**PSEG** Public Service  
Electric and Gas  
Company

April 24, 1984

NRC REVIEW OF STRUCTURAL/GEOTECHNICAL TOPICS  
HOPE CREEK GENERATING STATION  
DOCKET NO. 50-354

Attachment: Resolution of NRC Comments on  
Structural/Geotechnical Topics

FIGURE 1

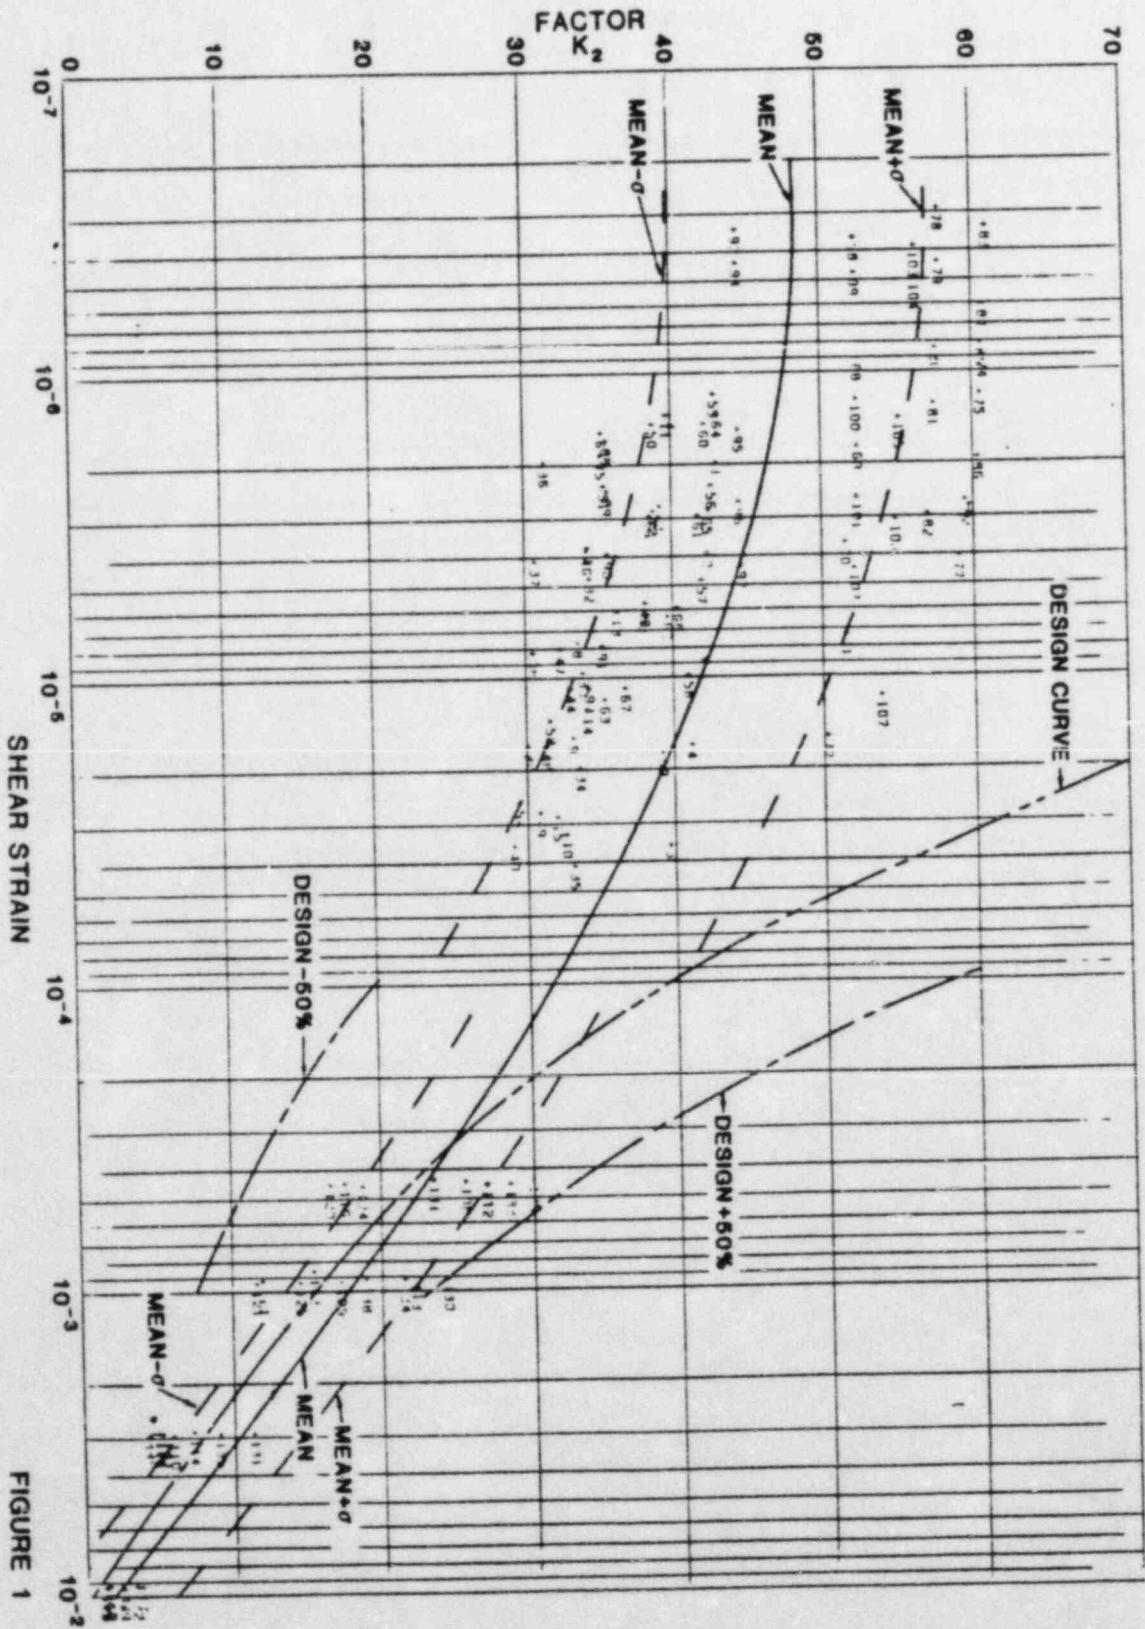
QUESTION: Verify that soil shear moduli variation of  $\pm 50$  percent is at least one standard deviation based on soil test data.

A mean curve to these data is shown by the solid line in Figure 1. Standard deviation was computed separately for strain controlled cyclic triaxial test data and resonant column test data. Limits for one standard deviation are shown by dotted lines. Figure 1 also shows the design curve used in dynamic analyses and the range of soil shear moduli variation of  $\pm 50$  percent. The seismic induced effective shear strains are typically in the range of  $10^{-3}$  to  $10^{-4}$  in/in.

Comparison of the curves indicates that the soil shear moduli variation of  $\pm 50$  percent envelopes the standard deviation curves at seismic induced strain levels. The soil shear moduli variation of  $\pm 50$  percent, therefore, includes the variation in Laboratory data in the area of interest.

FIG. 1 - A

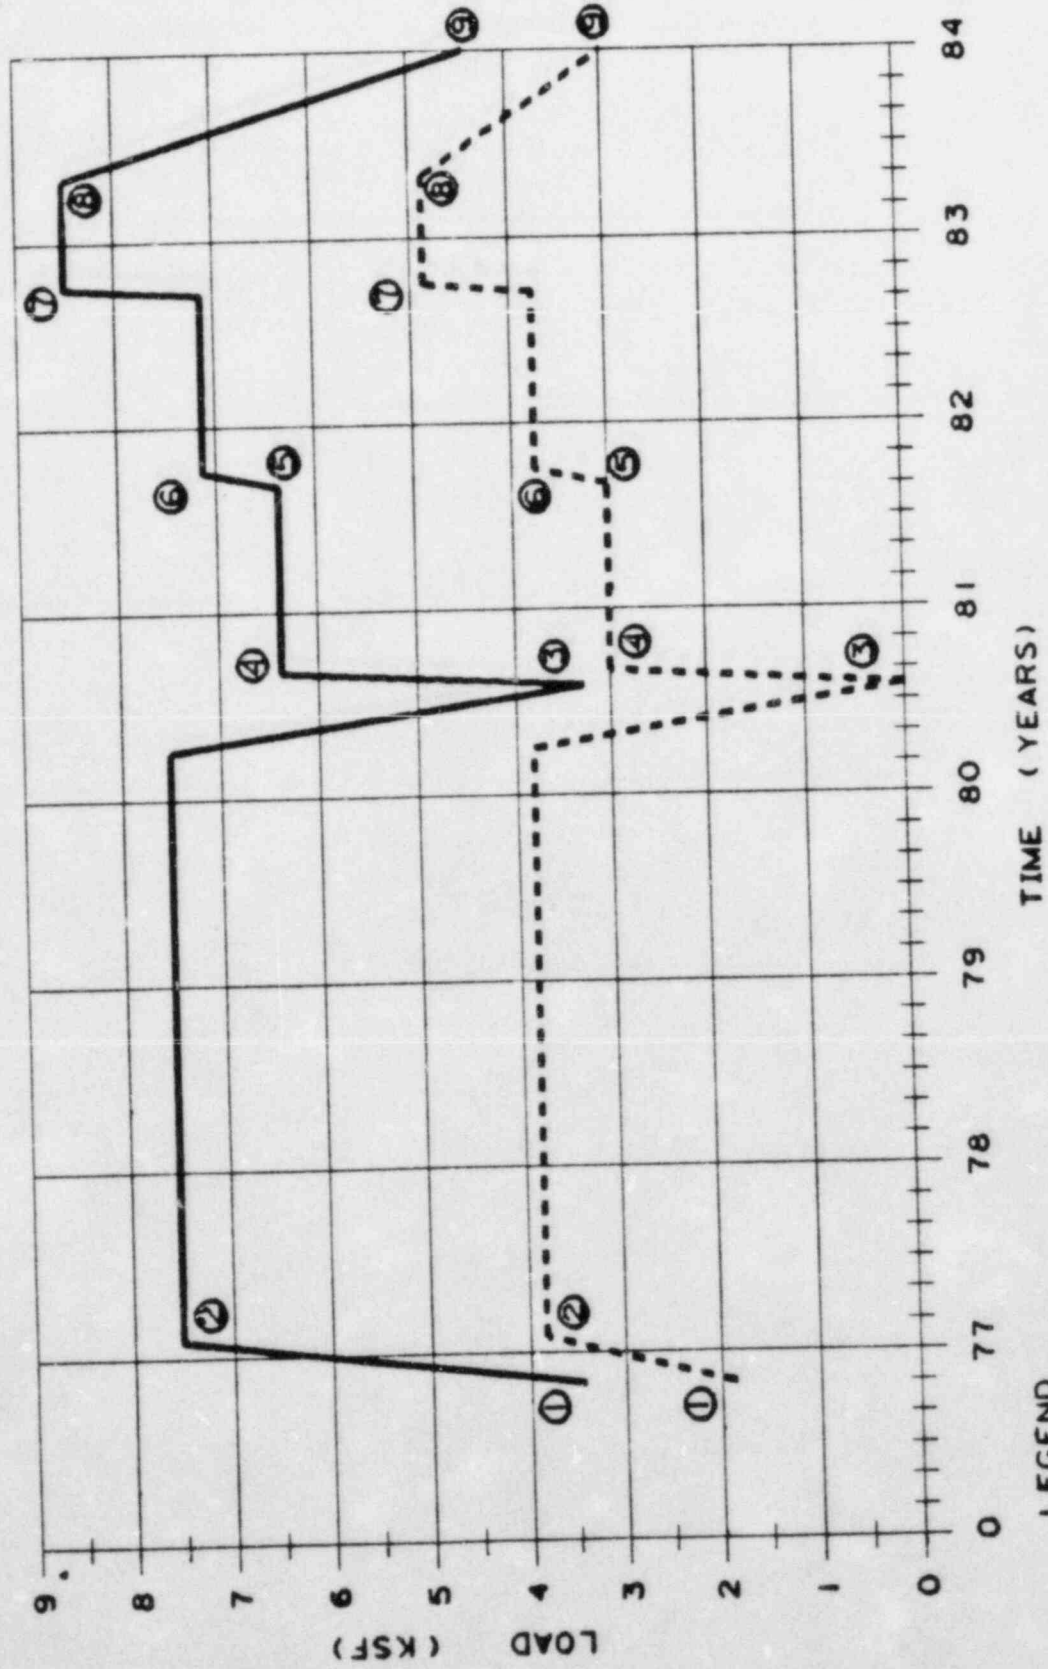
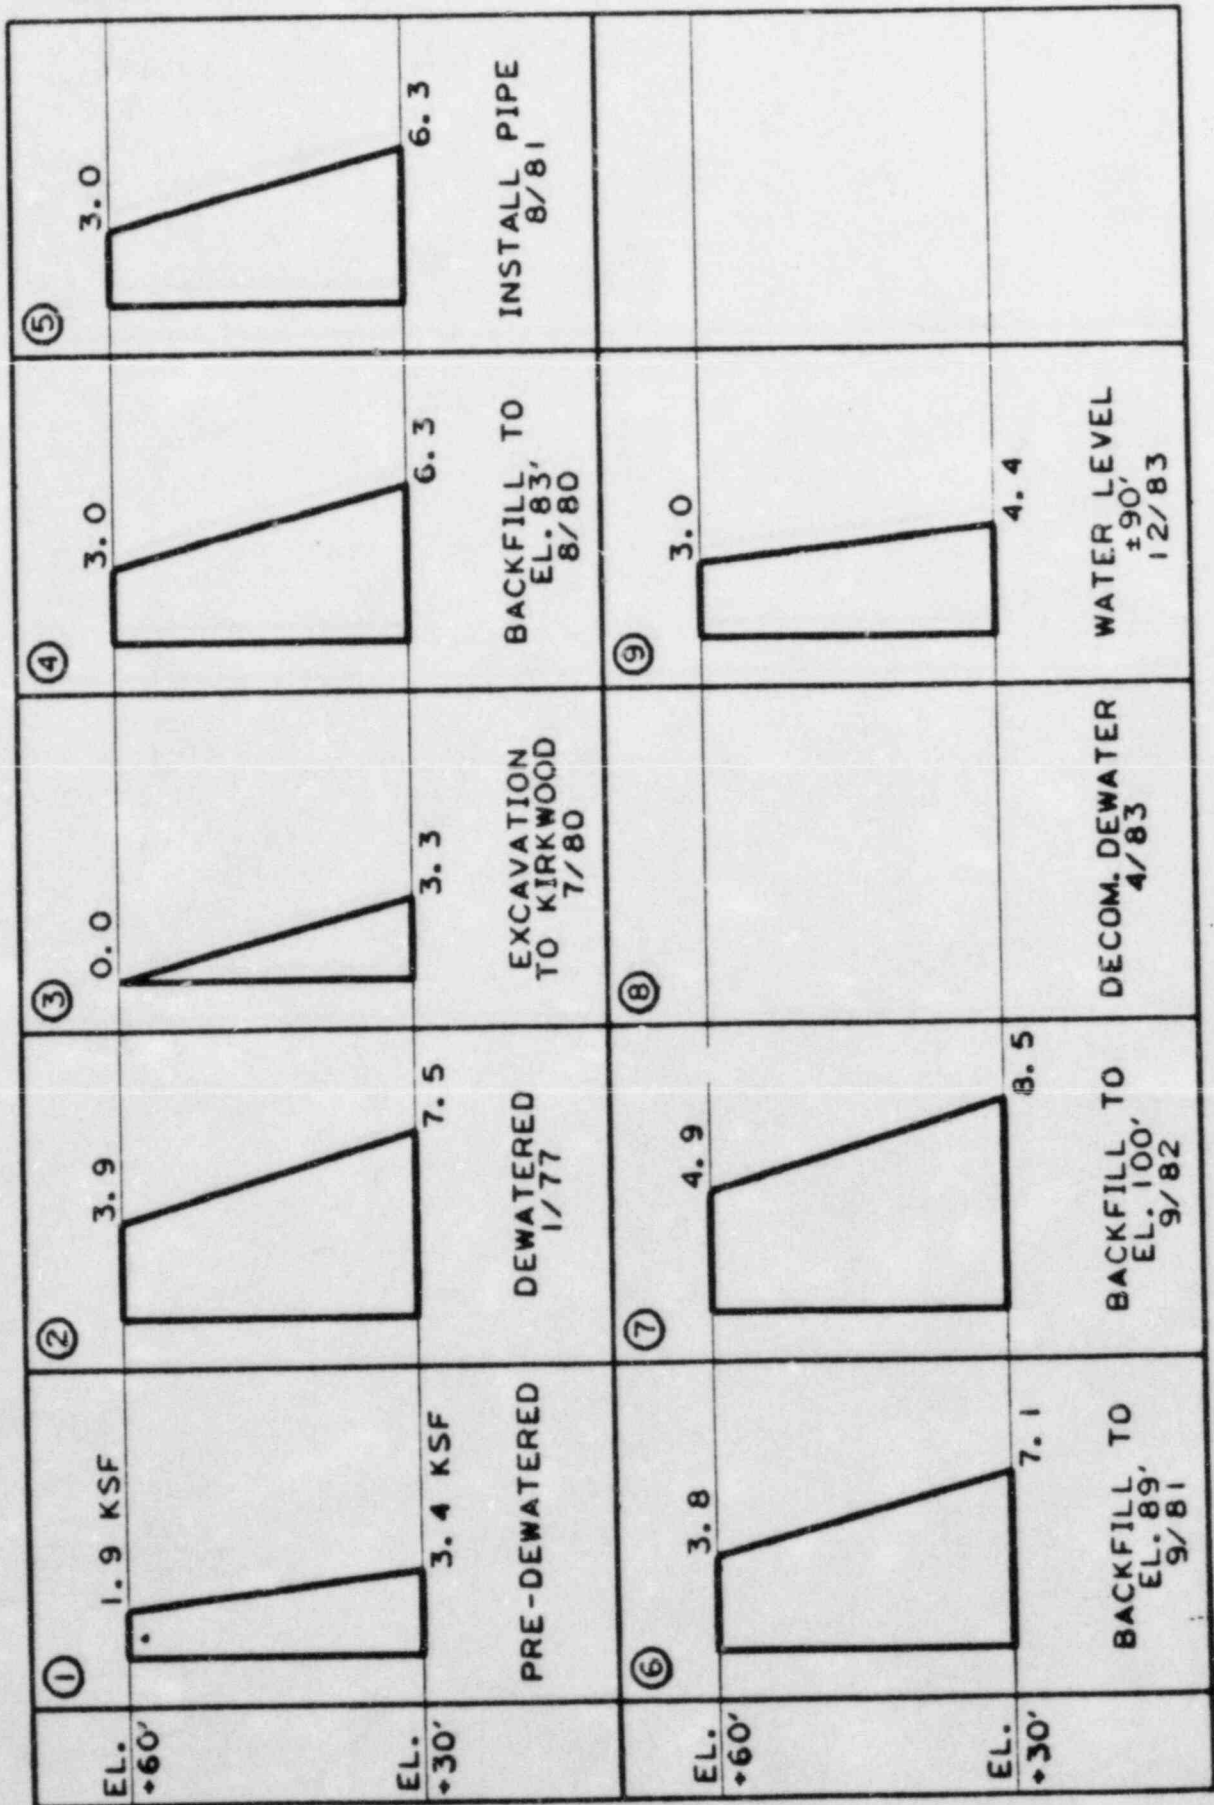
Current settlement calculations for the service water pipe are based on average soil properties. Provide additional settlement estimates using actual soil properties at various sections along length of service water pipe line.

Settlements of the service water pipeline were estimated using average soil properties and a typical construction sequence. For the load-time history shown on Figure 1, the maximum total static settlement of the pipeline is estimated to be approximately 3 inches corresponding to a 30 foot thick Kirkwood clay layer. The settlements would be less for a smaller thickness of Kirkwood clay. Differential settlements would primarily depend on the variability of the Kirkwood clay layer thickness. This variability however will be negligible within each 20 foot segment of the pipeline, except near the power block area where the pipeline crosses the main excavation slope. The maximum differential settlement within a pipe segment is expected to be on the order of 1 inch in that area.

FIGURE - 1

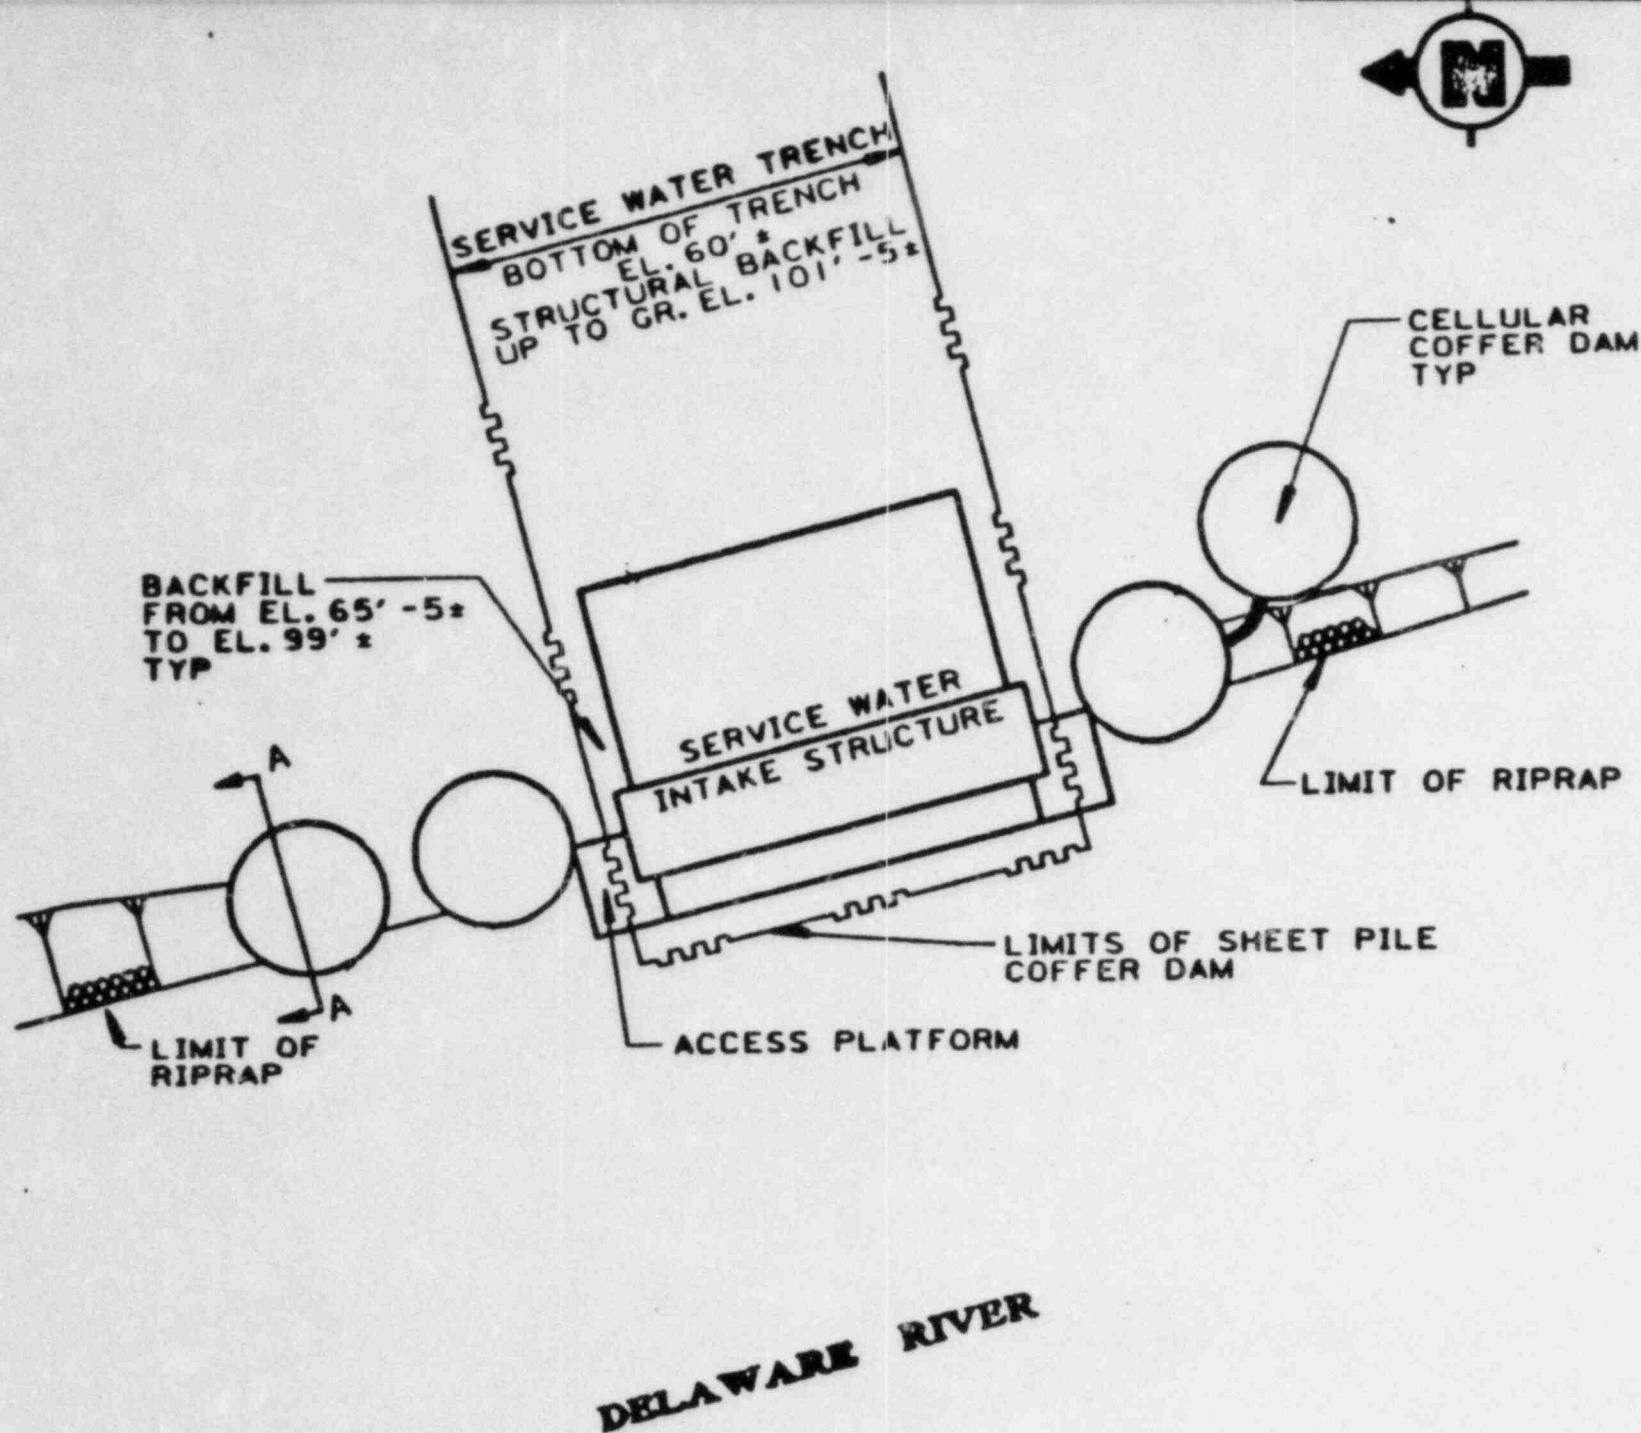
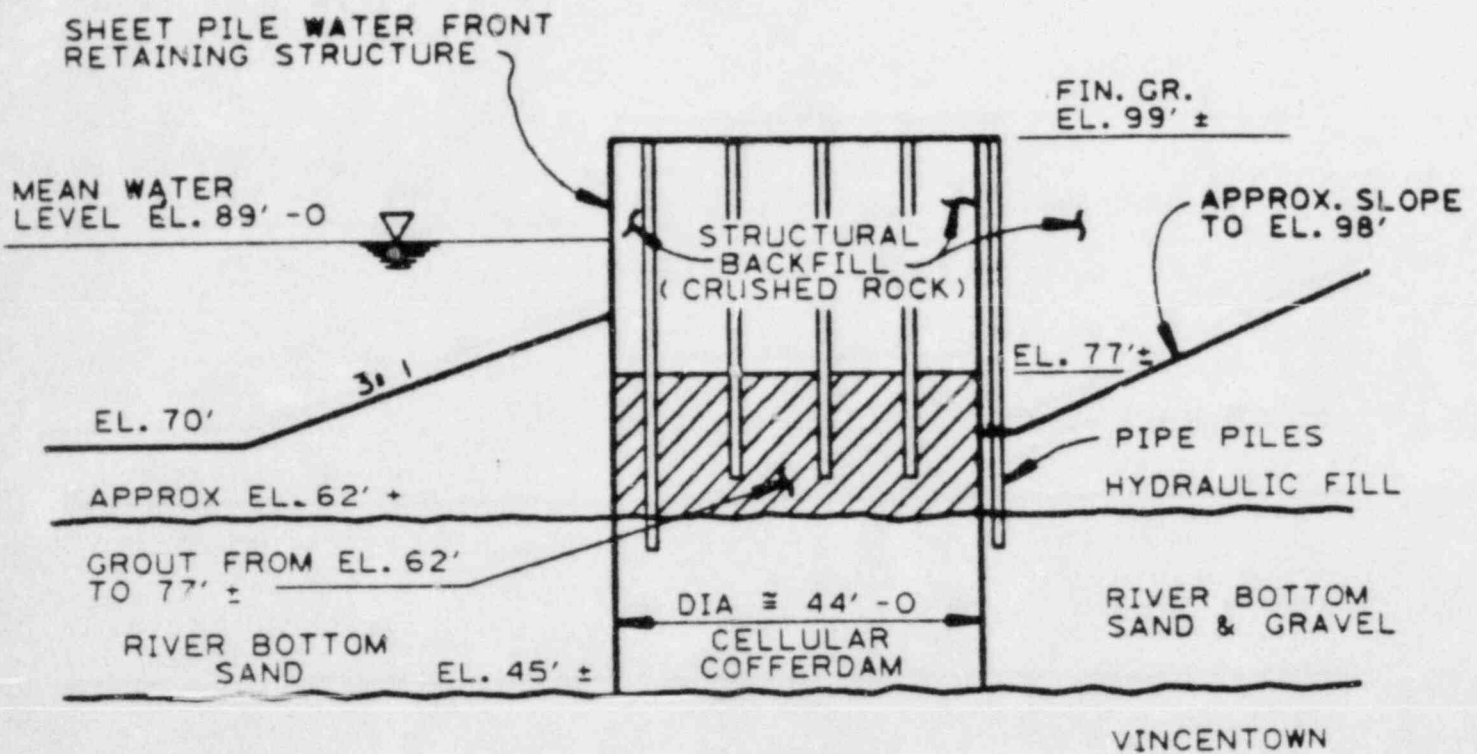
QUESTION: The response to FSAR question 241.29 should include information on gantry crane piles (including pile tip elevations) and cofferdam configuration adjacent to intake structure. Provide design summary for Cofferdam stability during seismic events without considering liquefaction of soils.

RESPONSE: The Service Water Intake Structure gantry crane support consists of six pile supported foundations. These foundations are independent of the cellular cofferdams. Each foundation contains ten-14 inch diameter by 3/8 inch wall concrete filled pipe piles. The piles are driven to refusal for a 100 ton pile with tip elevation generally varying between elevation 0 feet to 20 feet. All piles are protected by a cathodic protection system. A design summary for cofferdam stability during an SSE event without considering liquefaction of soil is attached. The cofferdam configuration adjacent to the intake structure is shown in the design summary.

Load combinations, key assumptions, and summary of safety factors for the cofferdam stability analyses are presented. Figures 1 and 2 show the cofferdam and surrounding area.
